HISTORIC AND DESIGN REVIEW COMMISSION

Agenda Item No: 20

HDRC CASE NO: 2016-208
ADDRESS: 2010 W MAGNOLIA AVE
LEGAL DESCRIPTION: NCB 192 BLK 10 LOT 26
ZONING: R6 H
CITY COUNCIL DIST.: 7
DISTRICT: Monticello Park Historic District
APPLICANT: Hilton Crocker
OWNER: Hilton Crocker
TYPE OF WORK: Widen driveway

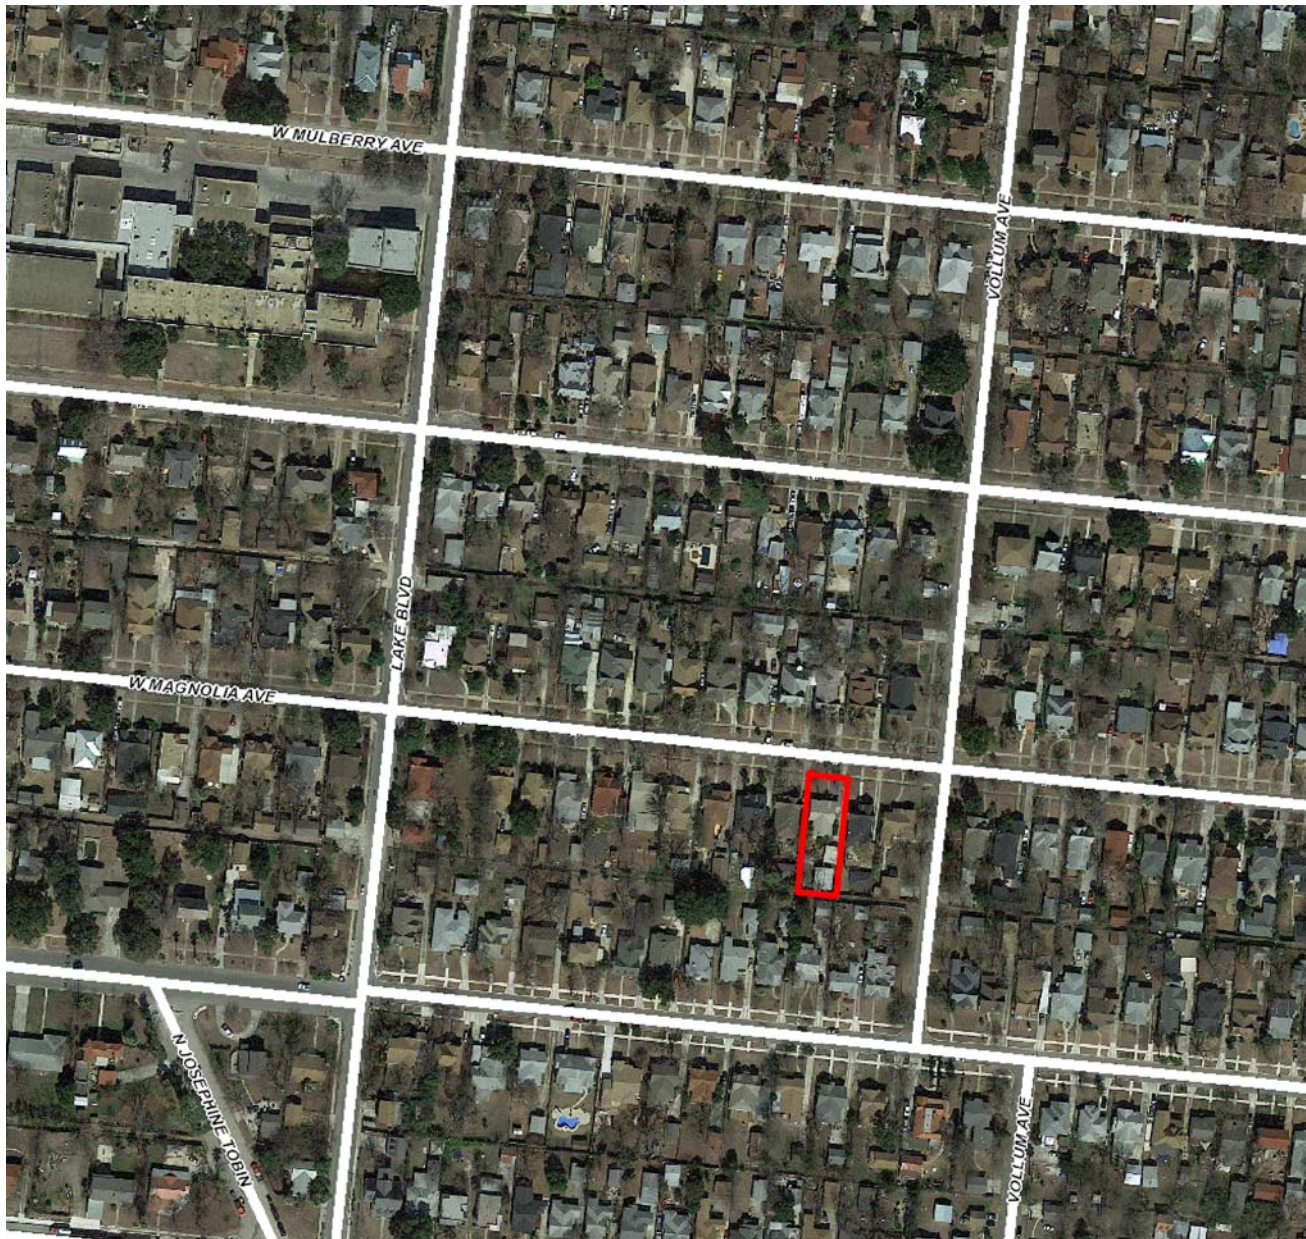
- a. This home is located in Phase 5 of the Monticello Park Historic District, which was designated May 16, 2010.
- b. The applicant is proposing to remove the existing ribbon driveway, made of two 2' concrete strips, separated by grass, and repour a 9' wide concrete driveway. The Guidelines for Site Elements state that historic driveways are typically no wider than 10' and that new driveway configurations should be similar to what's historically found in the district. Staff made a site visit on June 6, 2016, and found that driveways in Monticello Park Historic District historically are 10' wide.

- c. The Guidelines for Site Elements 5.B.i. also states that pervious paving surfaces may be considered when replacement is necessary.
- d. Ribbon driveways are character defining features of the property. Staff recommends that the applicant re-pour the historic driveway ribbon configuration and consider using a pervious material such as decomposed granite in the middle and to widen if necessary.

Staff recommends denial based on findings a through d. Staff recommends that the applicant repour the ribbon driveway in the same configuration as existing, and widen with pervious material up to 10'.

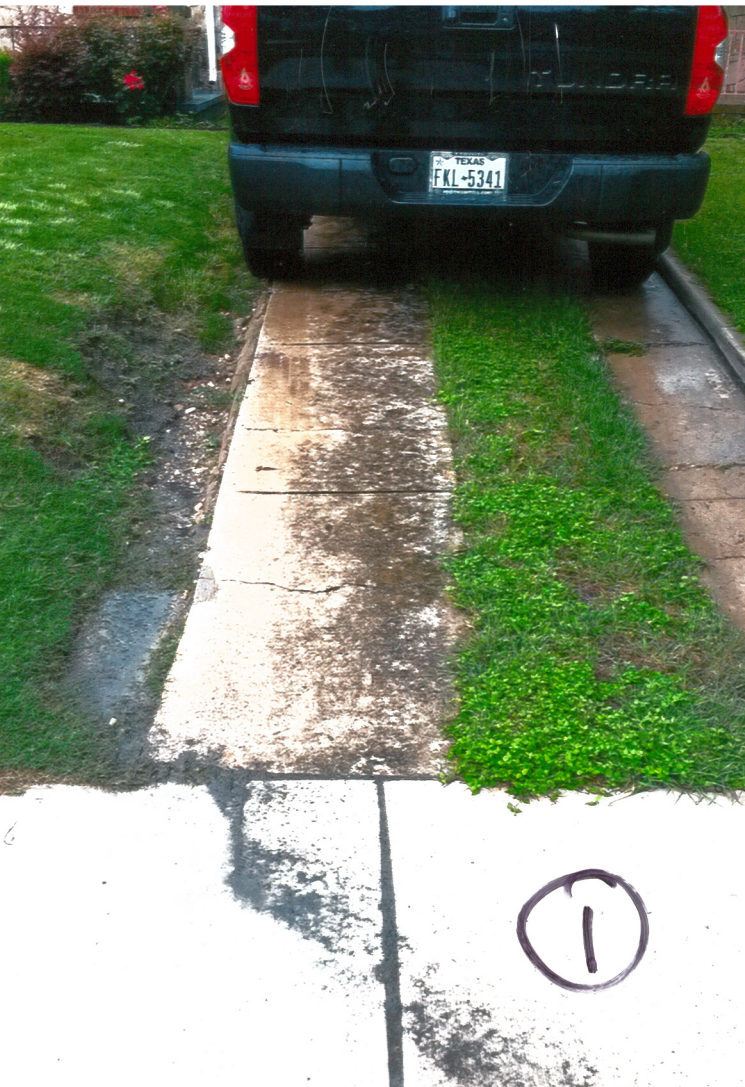
I recently purchased a home at 2010 W. Magnolia Ave. It is my desire to remove the old ribbon driveway and replace it with a solid surface driveway. I have included a site plan and photos. Photo #1 shows that the old driveway is not wide enough for current vehicles and has caused a gouging of the adjacent yard. Photos # 2 and #3 show damage to the driveway and yard from vehicular traffic. Photos #4 - #8 show the surrounding homes, on my block, that have upgraded to a solid surface driveway. Please give my proposed project your consideration.
